# PLANNING BOARD REPORT

Commercial Development including gas station and convenience store with ATM

2282 Congress Street

Level III Site Plan and Traffic Movement Permit

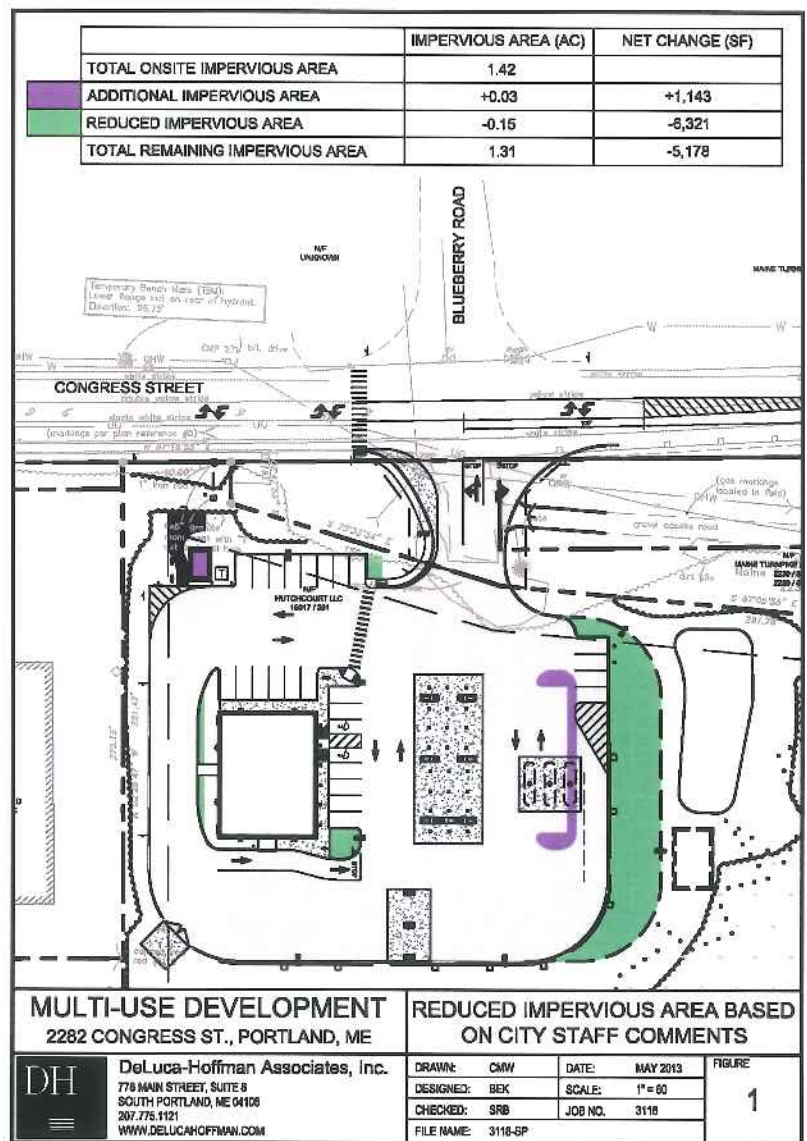
During the review staff raised concerns about the extent of the impervious surface (over 40% of the site), which was designed to accommodate maximum peak parking demand and provide ideal turning areas for very large tractor trailers. Although all of the stormwater run off would be treated, the key issue was that this created an expanse of pavement that was not consistent with the campus-like character required by the CZA.

The applicant reconsidered the parking and truck maneuvering requirements and was able to reduce the impervious area by 7% as summarized in the sketch at right.

Car parking for customers of the convenience store is now at 26 spaces, reduced from 32 spaces in the original site plan. The layout allows for the creation of parking spaces (in the green area of plan to the right) if future peak demand indicates a need for additional parking. Eight bicycle parking spaces are included and a truck parking area.
